FINAL
ENVIRONMENTAL IMPACT STATEMENT

URS Corporation
1421 Chapala Street
Santa Barbara, California 93101

This is a programmatic environmental impact statement (EIS) for adoption of the proposed Mineral Resource Management Plan (MRMP) for Vandenberg Air Force Base (VAFB).

Figure 7-2

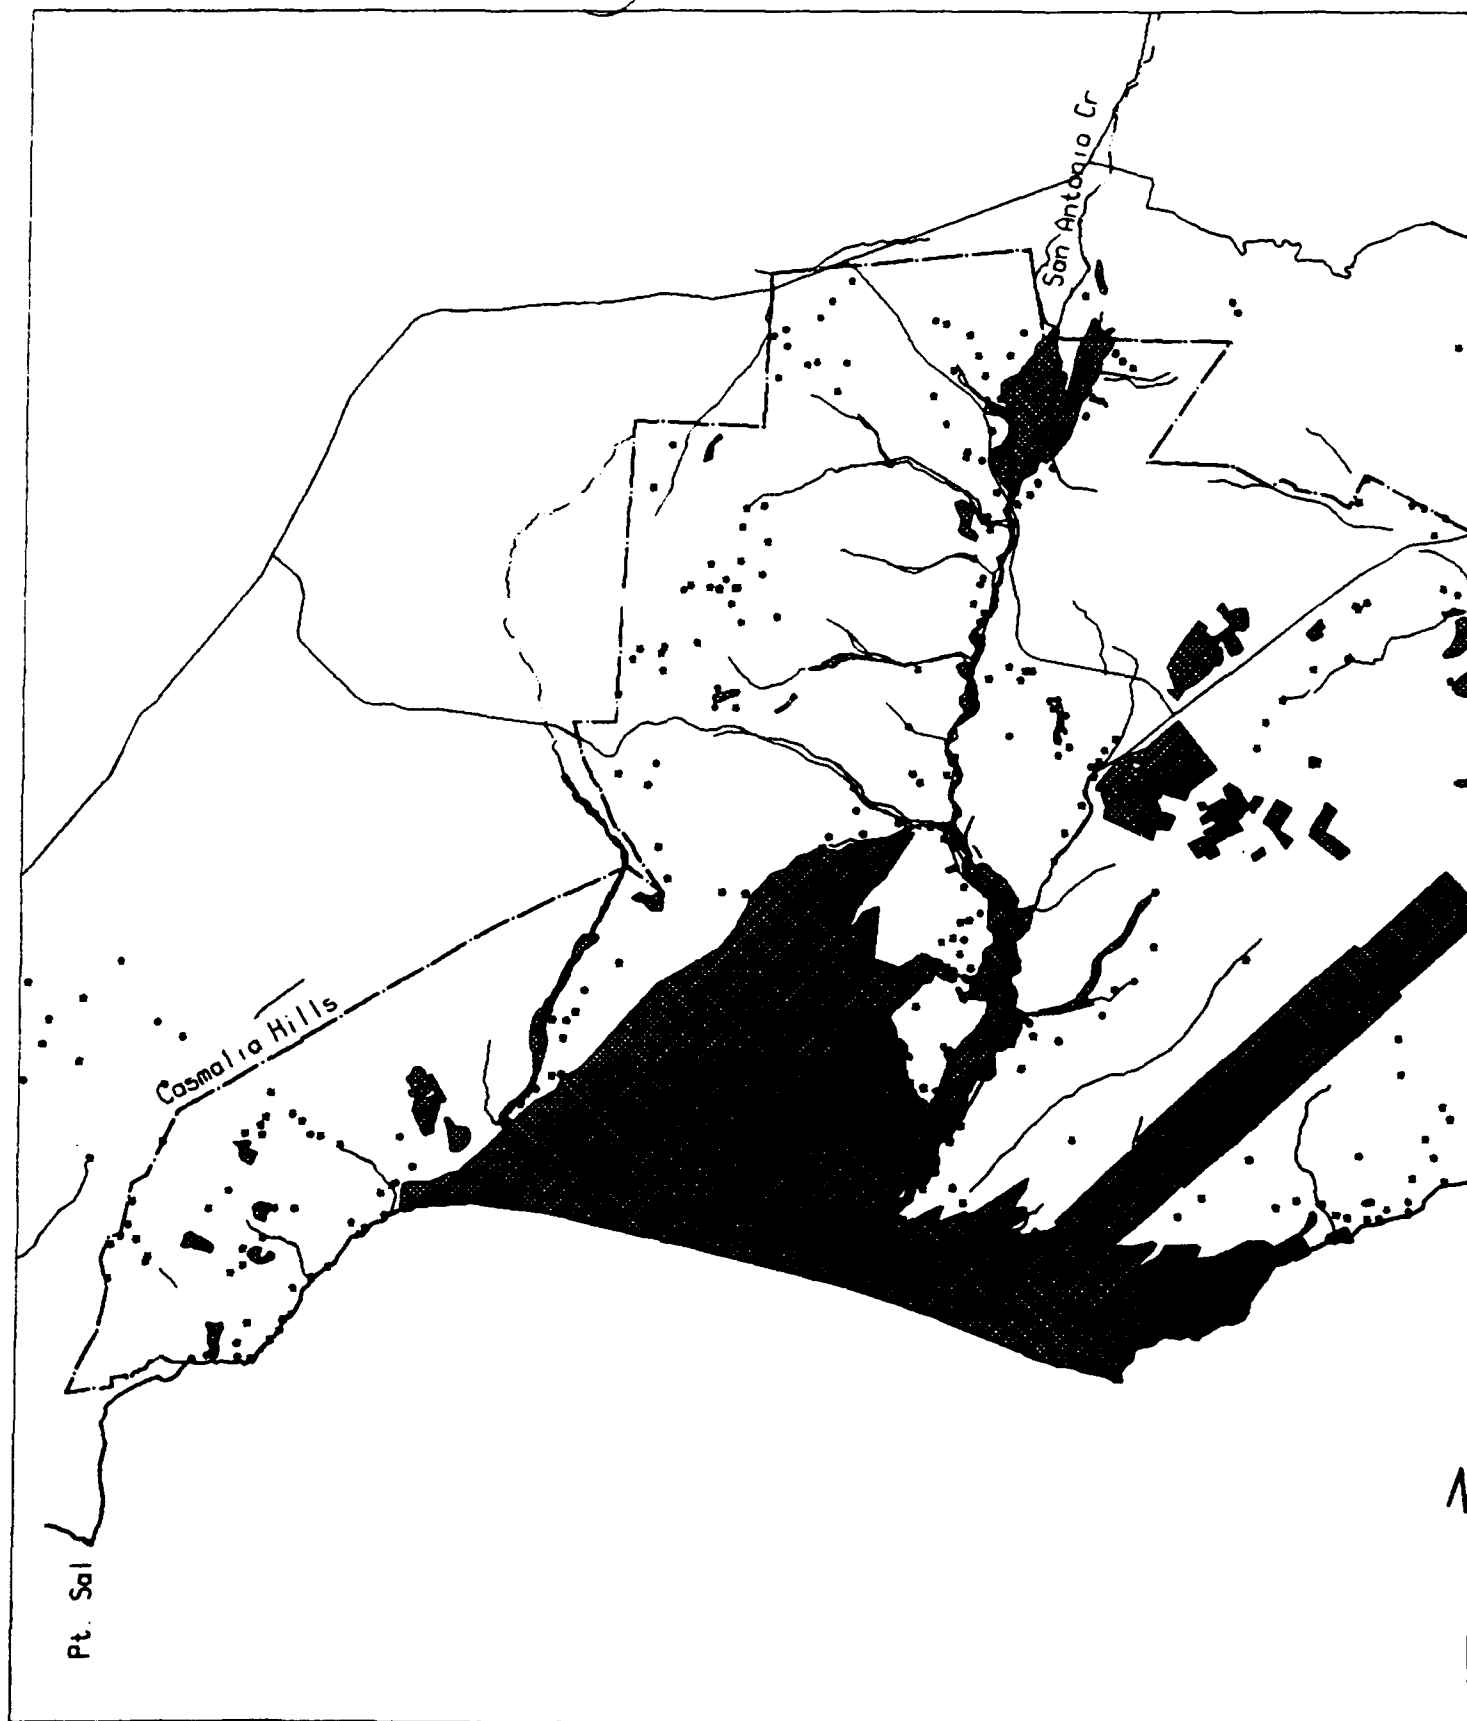
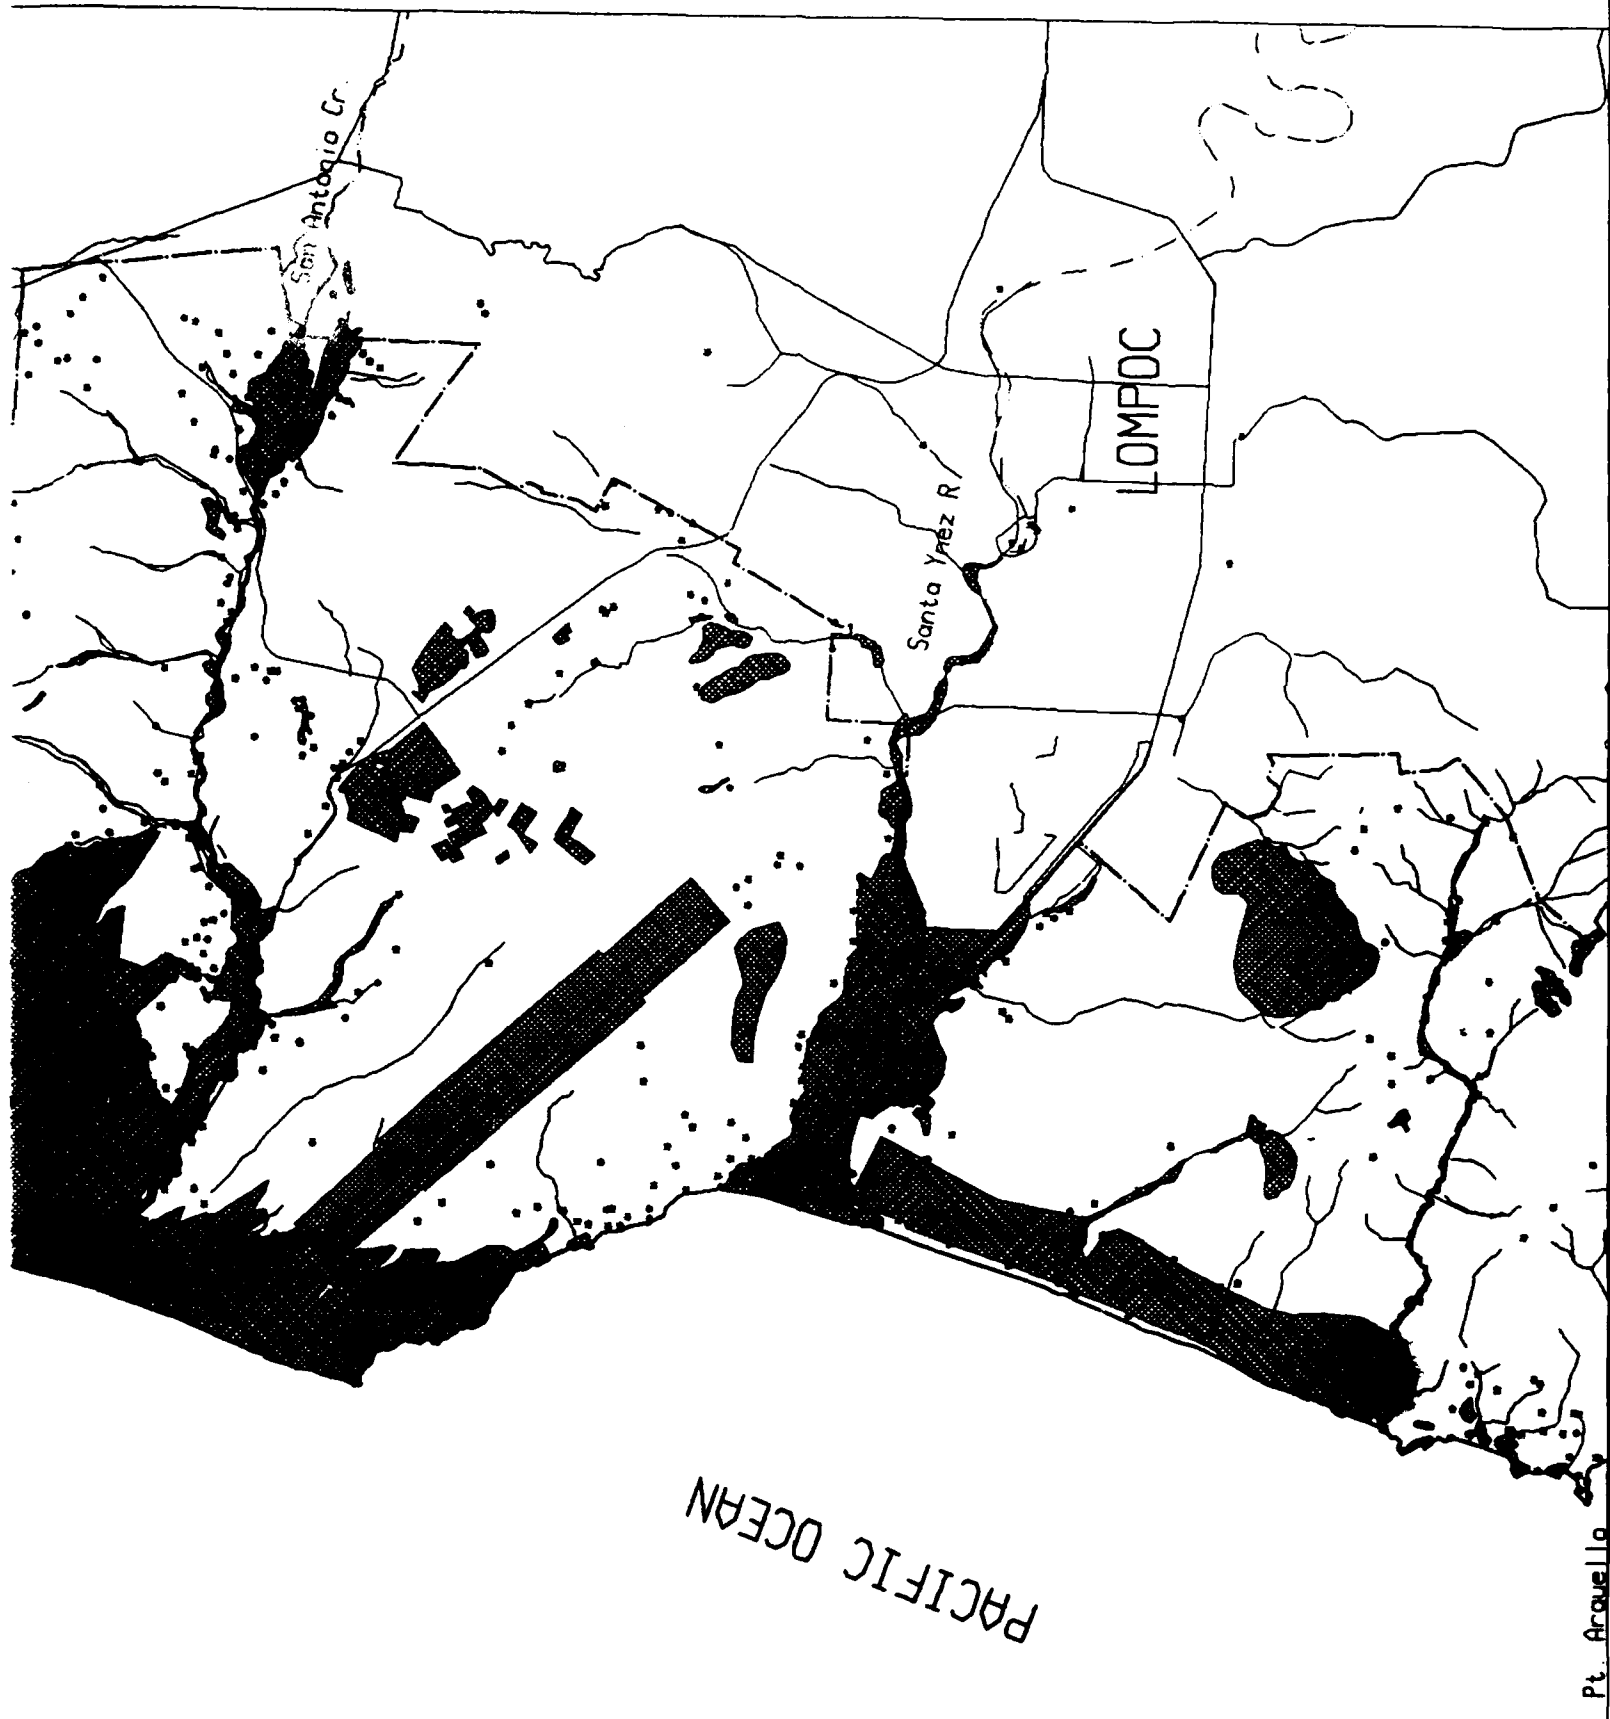
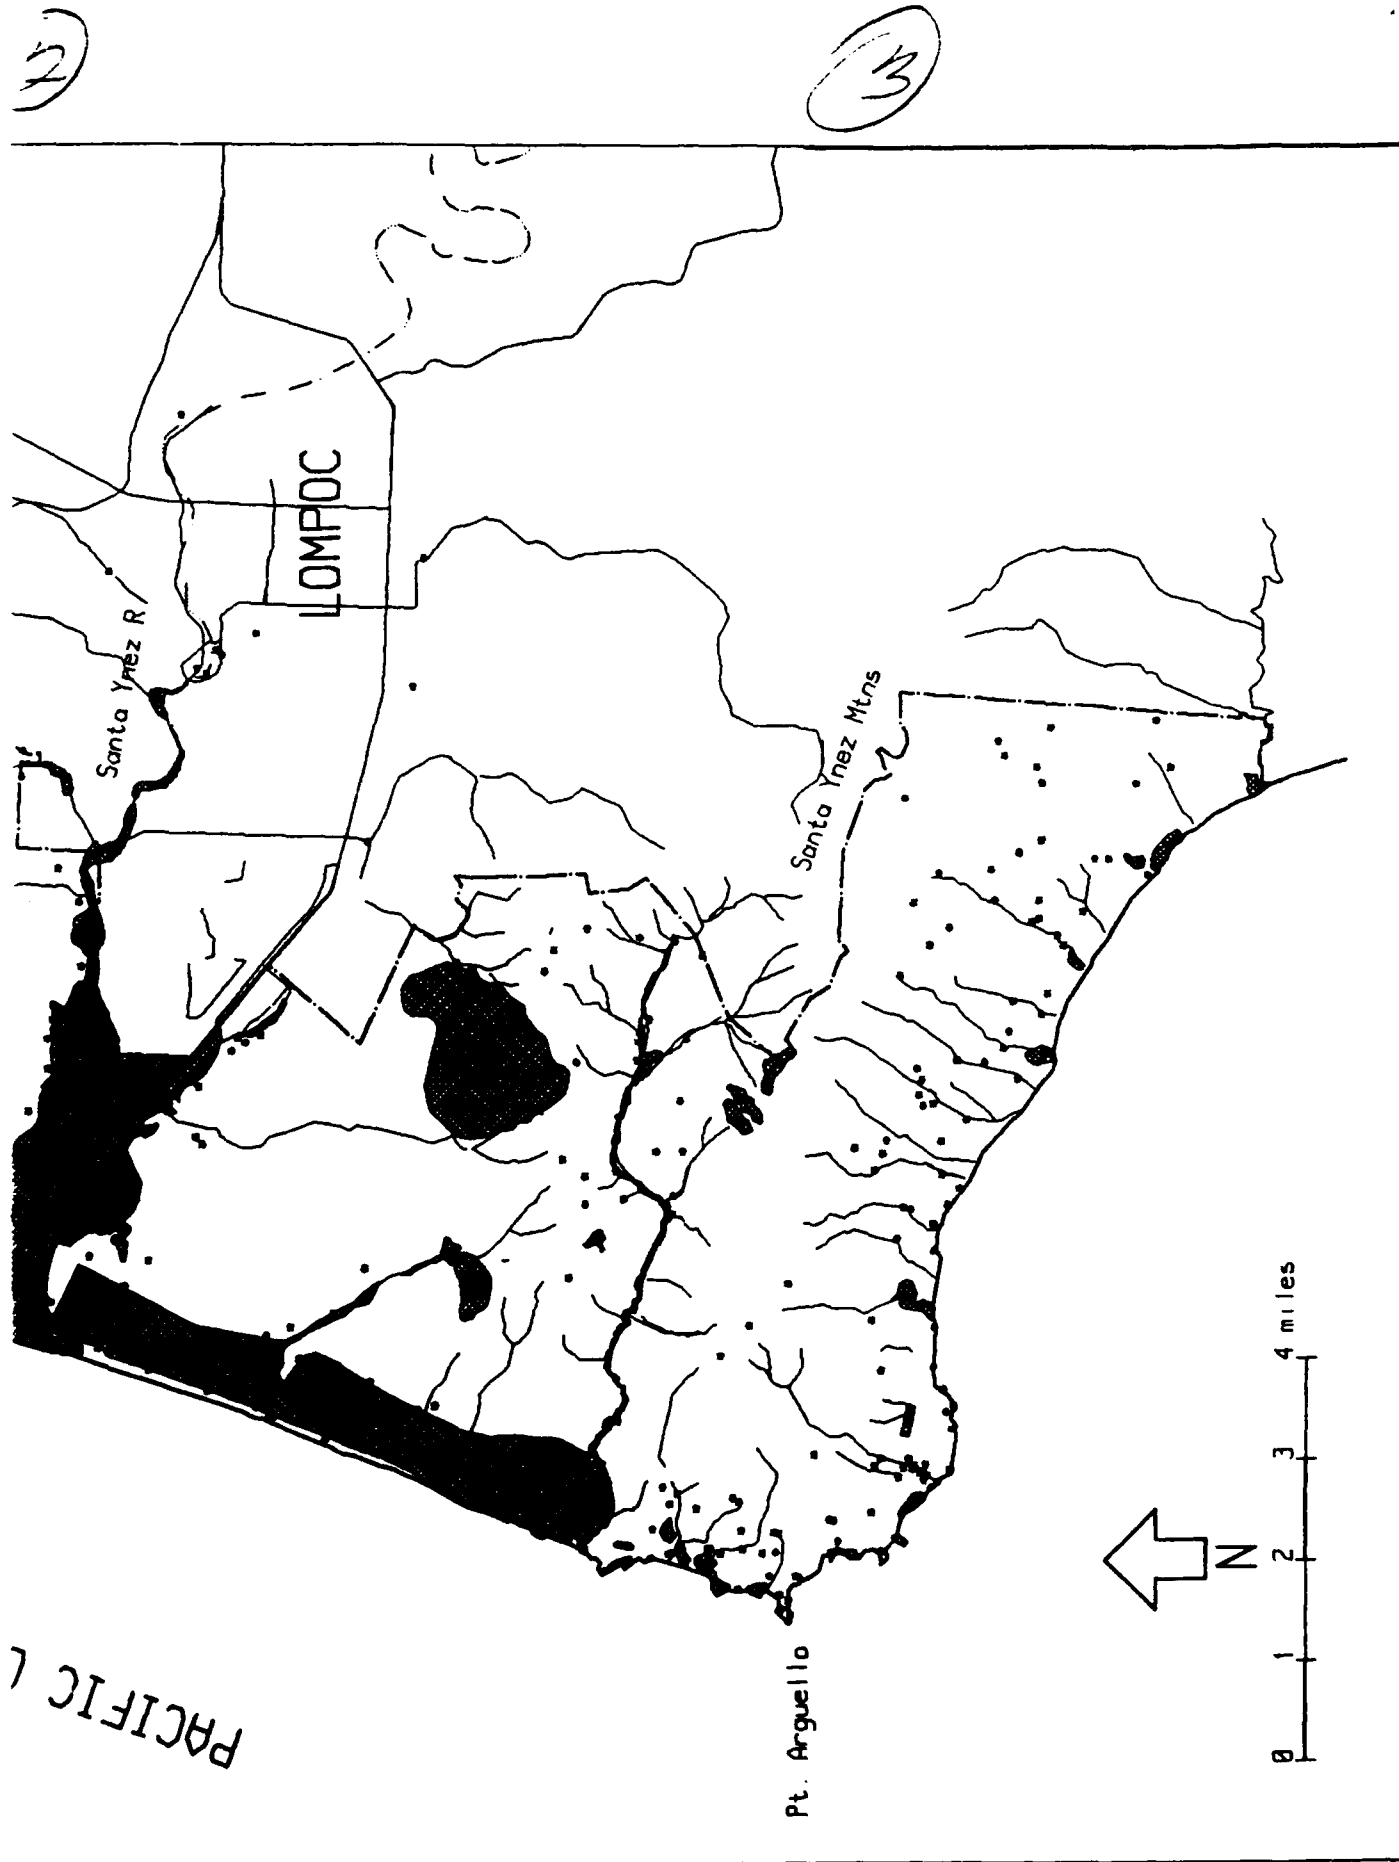
18. Figure 7.2, page 7-7. The LEGEND block is empty; either Legend text must be added, or the block must be removed. Also, this figure should include all lands within the Lompoc and San Antonio Groundwater Basins, since overdrafted groundwater resources are acknowledged in the text as a "high environmental constraint (see e.g. Sec. 6.2.4.1, p. 6.2-21, middle of first full paragraph; Sec. 7.3.3.2, p. 7-6).

A legend is unnecessary for Figure 7-2, Composite Environmental High-Constraint Areas, on page 7-7; therefore, the legend inset has been removed. See attached figure.

- RMD-131 See the response to comment SLC-1.
- RMD-132 The legend is unnecessary and has been deleted from Figure 7-2. Please see the MRMP errata for section 7.0, Plan Criteria and Application. The referenced map gives information on locations of oil and gas facilities which may be constrained by water resource attributes. As noted in the response to comment RMD-83, the location of oil field development is not geographically tied to the location of the water source which would supply the facility. The purpose of this figure is to provide geographic information on constraints of oil and gas development on base.
